# CITY OF ALBUQUERQUE

**RE: Fire Station #9**  
**Grading and Drainage Plan**  
**Engineer's Stamp Date: 09/14/2018**  
**Hydrology File: H20D043**

Based upon the information provided in your submittal received 09/21/2018, the Grading and Drainage Plan cannot be approved for Site Plan for Building Permit, Building Permit, Work Order, or Grading Permit until the following comments are addressed.

B1 OFF SITE-1 MAP  
ZONE ATLAS MAP H-20-C

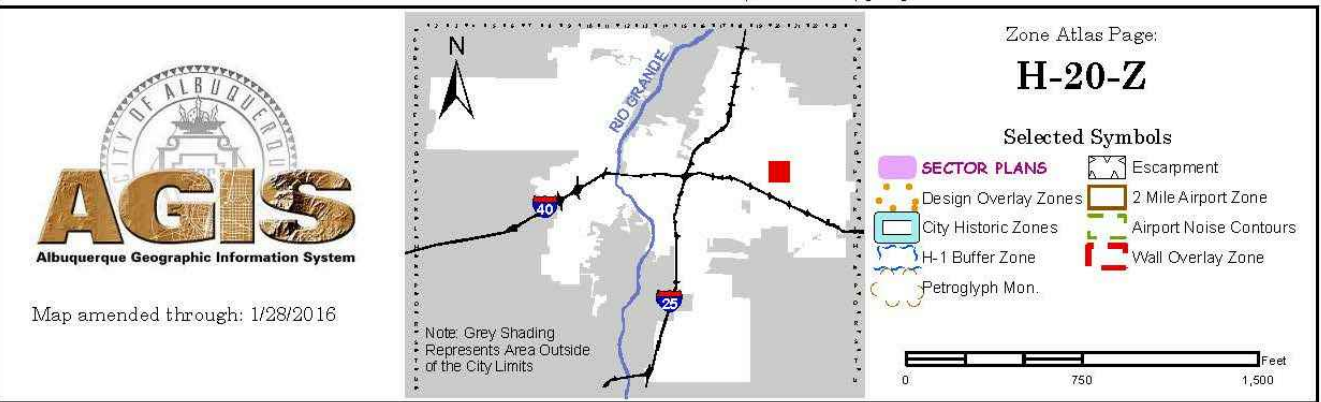
3. The drainage design of the Menaul Blvd infrastructure must be approved by Hydrology prior to approval of an Infrastructure List by the DRB. A Site Plan for Building Permit must be submitted to DRB. Additional offsite drainage basins must be identified and drainage infrastructure must be designed to accommodate the flows. The complete limits of the frontage improvements must be shown. Typical sections of the frontage improvements must be included on the plan with dimensions to the property lines and specifications for the improvements. Valley gutters must be added to the plan. The existing topo must be extended to the limits of the frontage improvements and at least 50' beyond. If the frontage improvements are being designed separately then that design must be approved before this plan can be permitted.

5. This site has two drainage outfalls, one to Menaul Blvd at the northwest corner of the site and the second to Towner Ave through the southwest corner of the site. Onsite drainage basins to each outfall must be identified on the basin map. Calculations of the 100 year peak flow rates to each outfall must be shown on the plan together with hydraulic calculations demonstrating the adequacy of the conveyance systems.

Drawing Title		GRADING AND DRAINAGE PLAN	
Design Review Committee		City Engineer Approval	
Issue Date:		City Project No.	
SEPTEMBER 14, 2018		5476.91	
Last Design Update		Sheet	
		C-101

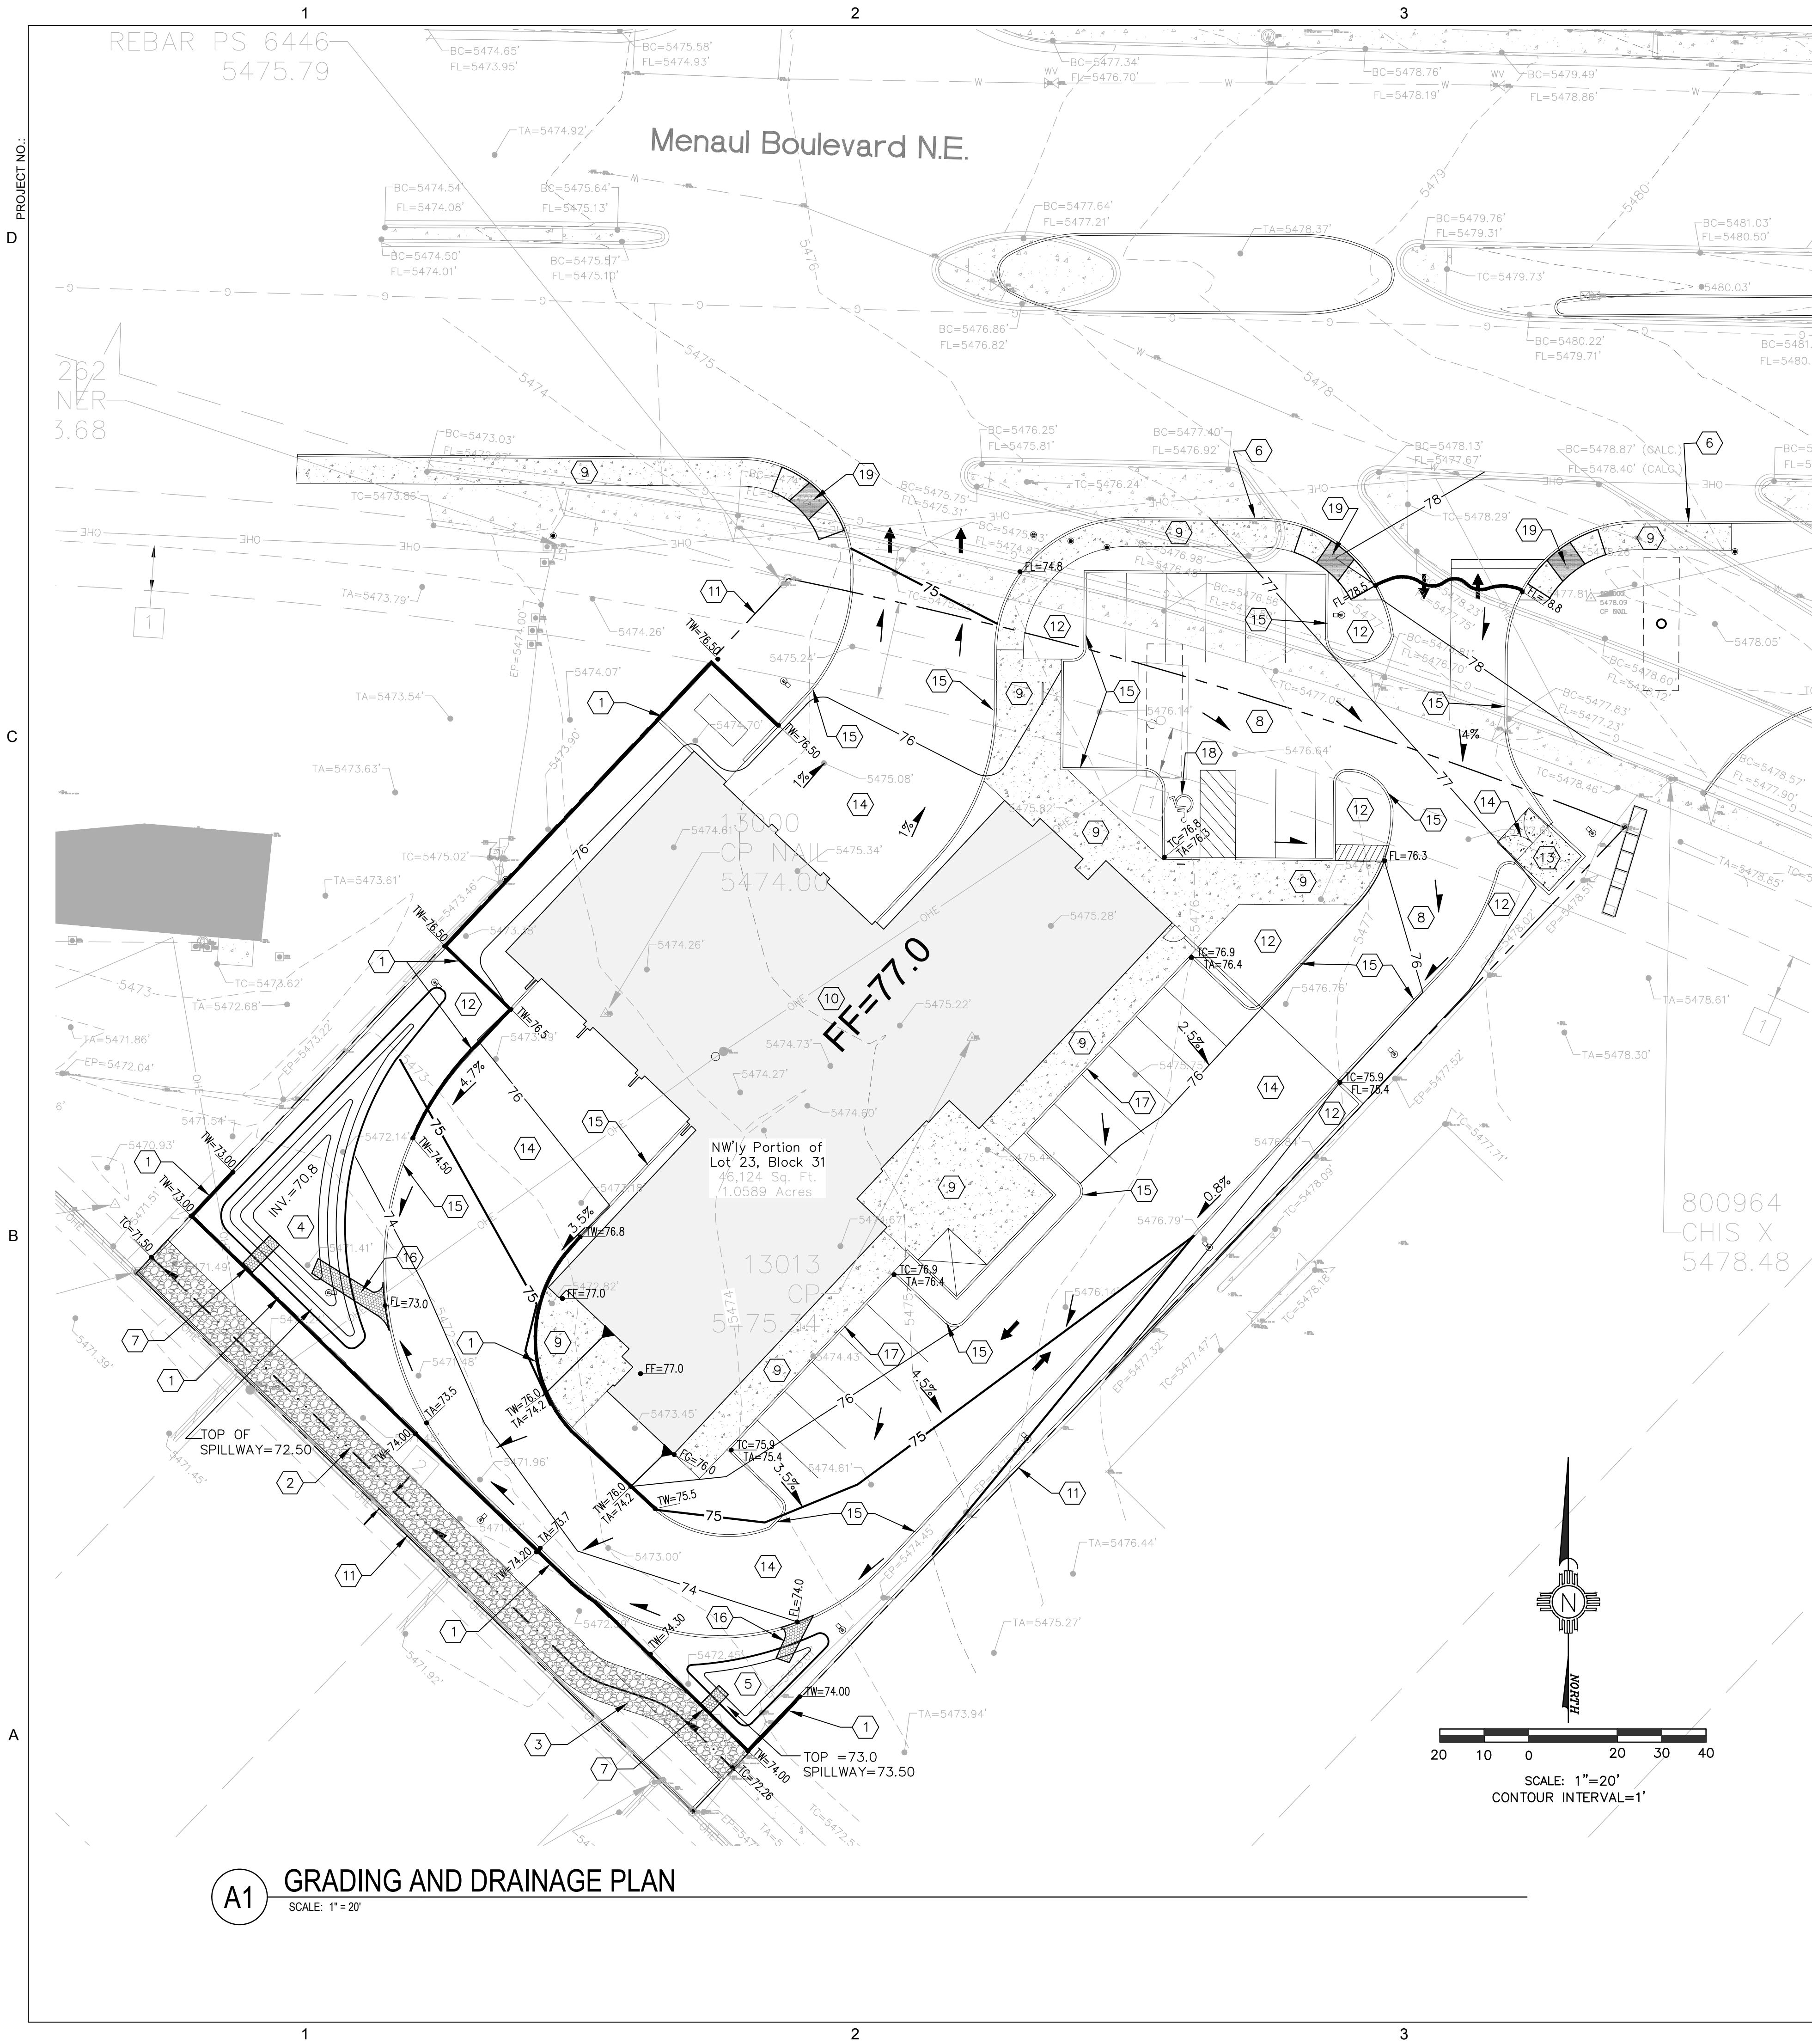
1. A Site Plan for Building Permit must be submitted to DRB and an Infrastructure List must be unanimously approved by the Board.
2. A Work Order will be required for the frontage improvements, so an SO-19 permit cannot be issued for this site. The SO-19 notes must be removed from the plan.

4. The parking lot on the north side of the building cannot be constructed in Menaul Blvd Right of Way as shown. The vacated portion of the Menaul right of way must be shown on the G&D Plan and the parking lot may not encroach into the right of way. The grading and drainage plan must identify new paths for the public drainage, and if it crosses the private property public drainage easements must be granted on the plat that will finalize the vacation. An additional private drainage easement must be shown on

the plat with maintenance and beneficiary for the southerly flow path through this lot. Provide a copy of the plat with the next hydrology submittal.

7. Each first flush pond should be sized for 0.34" of runoff from the impervious area draining to it. The City doesn't give credit for extra volume in a pond over and above that which is required for the impervious area draining into it. Roof drainage patterns and drainage basins must be identified for the area draining to each pond and for any area that doesn't drain to a pond. A waiver may be requested for impervious surfaces not meeting the required first flush volume together with justification for requesting the waiver. The waiver request must state the area of impervious that won't drain to a pond and the associated first flush volume. Put all of the required first flush calculations together in one location on the G&D Plan.

8. The proposed contours must be labeled in the ponds and pond volume calculations must be included on the plan based on the area inside each contour.
9. Both the first flush and the 100 year water surface elevations must be labeled on each pond. Hydraulic calculations are required for the overflow from each pond to determine the 100 year elevation and to demonstrate the adequacy of the pond outfall structures. Typical sections, details, and construction specifications must be included on the plan for the pond outfall structures, and all other conveyance structures. Hydraulic calculations are also required for the rundowns into the ponds.

10. Typical sections are required for the north, south, east, and west boundaries showing the property line, existing and proposed grades, and horizontal and vertical maximum and minimum dimension. Include typical sections through ponds, retaining walls, and the adjacent sidewalk, curb and gutter, paving and valley gutters. Wall footings must not encroach into adjacent property without written permission from the neighbor.
